Zoning Staff Report

Case Number: ZC-25-204

Site Location: 519 E. Butler Street/600 E. Ripy Street

Proposed Use: Elementary school

C1.01

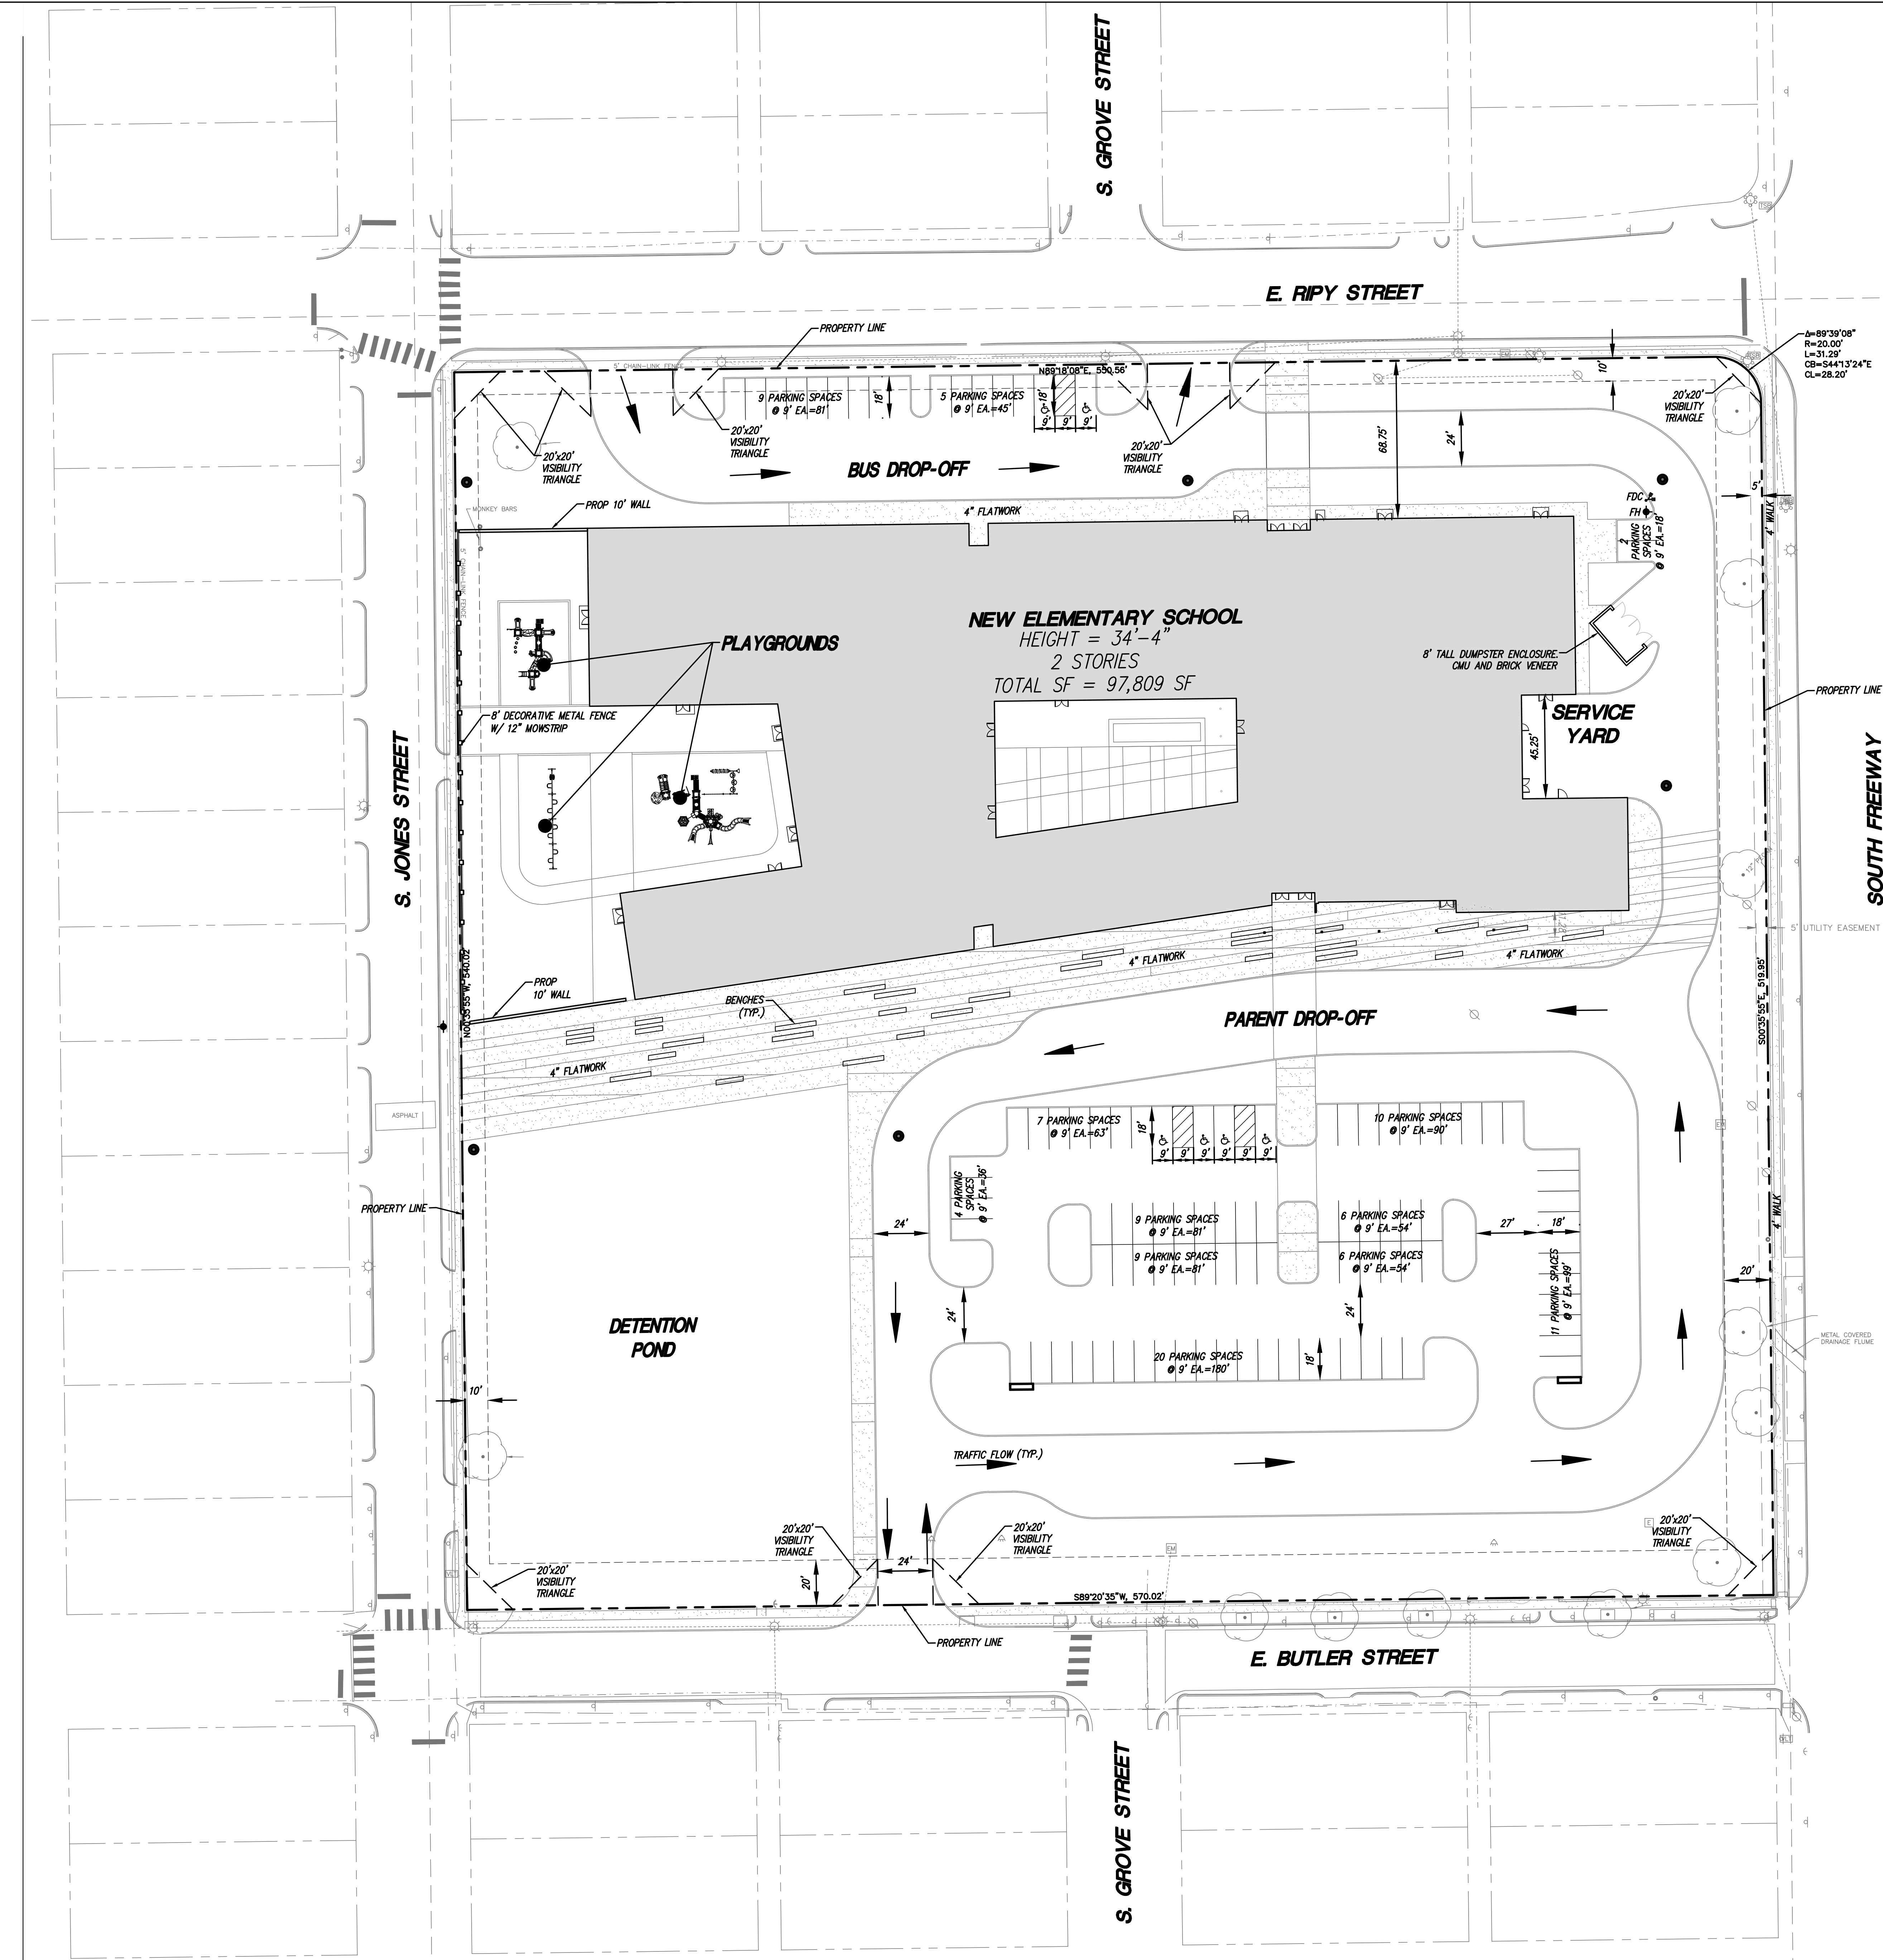
The site plan as submitted is not in general compliance with the Zoning Ordinance regulations. If approved, these comments would need to be addressed prior to ordinance adoption.

1. Add the legal description to the notes.

2. Add a vicinity map.
3. Label the zoning case number ZC-25-204 in the lower righthand corner of the plan, below the title
4. Provide a signature line labeled: "Director of Development Services" with a "Date" line above the project title.

5. Remove interim review note.
6. Include separate sheets showing the existing site layout, the interim construction phase with 2 buildings and 1 parking lot, and then a later construction phase with 1 building and 2 parking lots.

7. Note the new building's exterior construction materials.
8. Create a surface materials legend and add these colors/patterns to the main site plan. Include the surface materials of all ground level areas, including the driveway/parking materials and landscaping. Add this information to the main site plan, instead of a separate landscaping page.

9. Change the 10' wall to 10' fence.
10. Fencing over 4 feet is typically not allowed in a projected front yard in CF zoning. If approved, add the note in bold: "**A development waiver was granted to allow fencing up to 10 feet in a projected front yard.**"

11. Update the eastern side yard to 10 feet and the western side yard to 20 feet.
12. Parking is generally prohibited in the front yard in CF zoning. If approved, add the note in bold: "**A development waiver was granted to allow parking in the front yard.**"

13. Label the land use and zoning classifications of both the site area and the immediately adjacent properties abutting the site.
14. Add the note, "This project will comply with [Section 6.301, Landscaping.](#)"

15. Add the note, "This project will comply with [Section 6.302, Urban Forestry.](#)"
16. Add the note, "All signage will conform to [Article 4, Signs.](#)"

17. Add the note, "All provided lighting will conform to the Lighting Code."
18. The bulk of the required landscaping would generally be along I-35W since that is the widest adjacent road. If approved, add the note in bold: "**A development waiver was granted to provide the required landscaping along S. Jones Street.**"

1. Adequate access is provided with existing public roadways and driveways that may be marked as fire lane.
Building hose lay is provided within 300' from existing public streets. 300' may be allowed where automatic fire sprinkler systems are provided.
The need for marked fire lanes will depend on the location of the Fire Dept Connection for the automatic fire sprinkler system(s). The FDC must be within 50' of a marked fire lane or public street.
Section 503.1.1 Buildings and Facilities
Section 912.2 FDC

1. This site requires a Traffic Impact Analysis and a Traffic Management Plan. The results of the TIA and TMP may require alterations to this site plan to prevent, to the extent possible, unnecessary queuing onto public ROW during pick-up and drop-off.

4. Sidewalk minimums (before consideration of pedestrian traffic impacts in the TIA) are 5-feet on all non-TxDOT frontages. Wider sidewalks may be needed to safely accommodate students during pick-up and drop-off
